Validation 1 results of Indian Vehicles on LPVC Version 1.4 and Issues pertaining to WLTC Version 5

Mr H A Nakhawa, ARAI, Pune, India

**13th DHC Informal Group Meeting
64th GRPE Session, June 2012**

Validation 1 Test on Low Powered Vehicles and Issues pertaining to WLTC Version 5

Results of Validation 1b

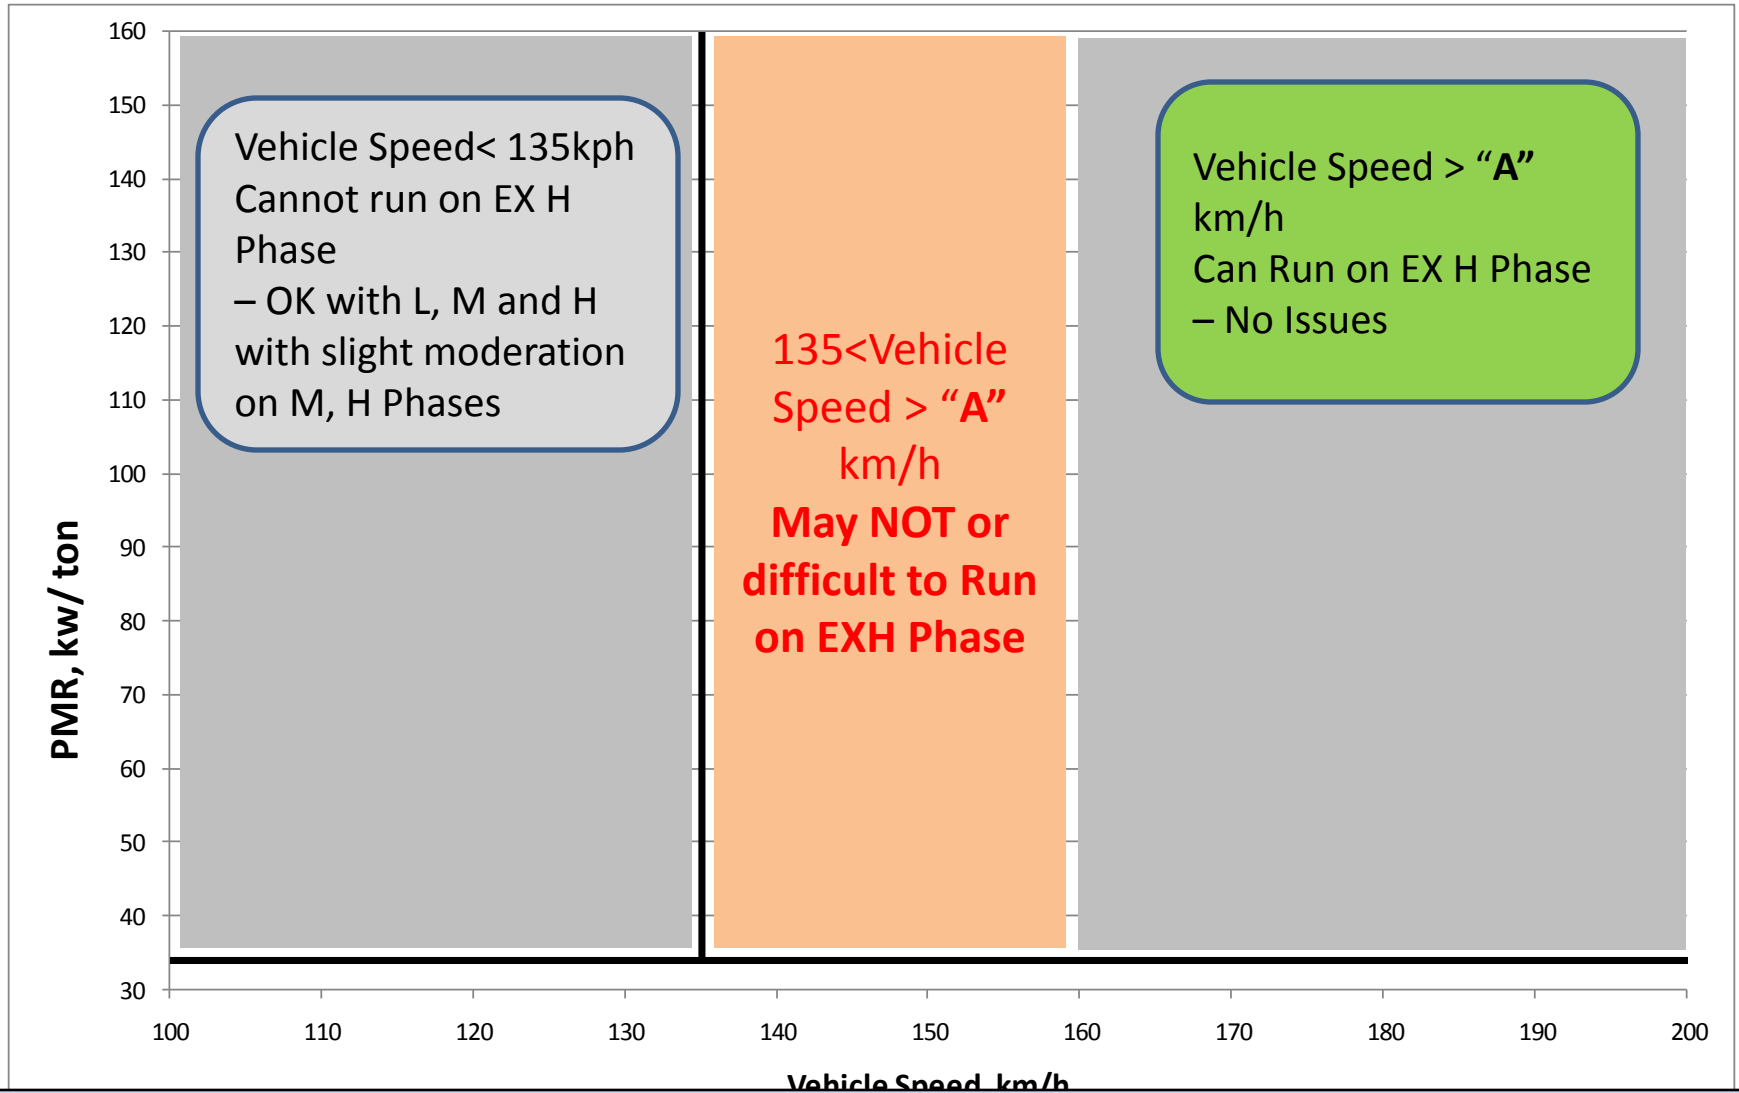
•Most of Indian Compact Cars fall in Class 3 Category. Validation 1b Test Results, show that these vehicles cannot drive High and Ex-High Phases of the Current Version of WLTC.

•Class 3 cycle demands such cars to be driven in WOT (the Engine Protection Area) which is rarely used in actual driving situations.

•India has already cited these concerns related to drivability during 12th DHC Meet at ISPRA

Cycle Class 3 Speed Threshold Change Proposal

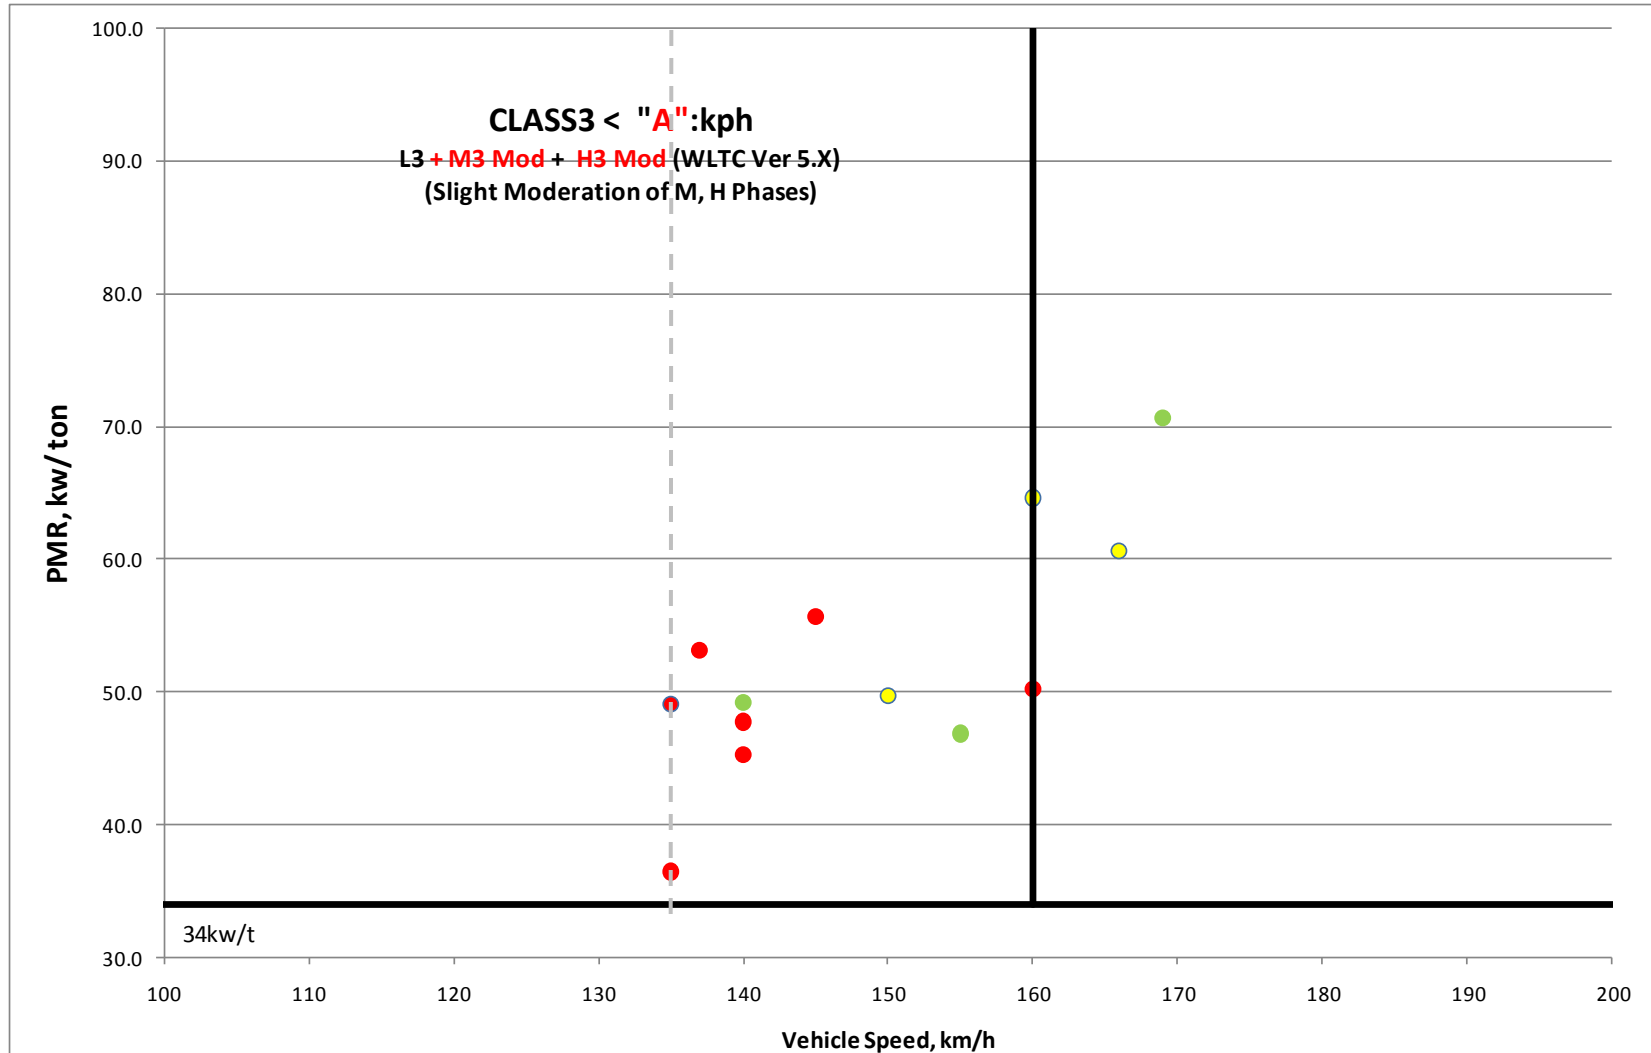
Vehicles having max speed slightly > 135 km/h with lower PMR (power ~ 60 kW) will not be able to:

- 1. Trace the EX H Phase, and /or*
- 2. May trace but with engine in WOT (engine protection region)*

*It is proposed to have the EX H Phase applicable for vehicles with Max speed around 155~160 km/h. Even with 160 km/h, some vehicles will have issues, however they are in the borderline areas. **This change along with the slight moderation for M and H Phases should make the cycle conducive for application in major areas of the world***
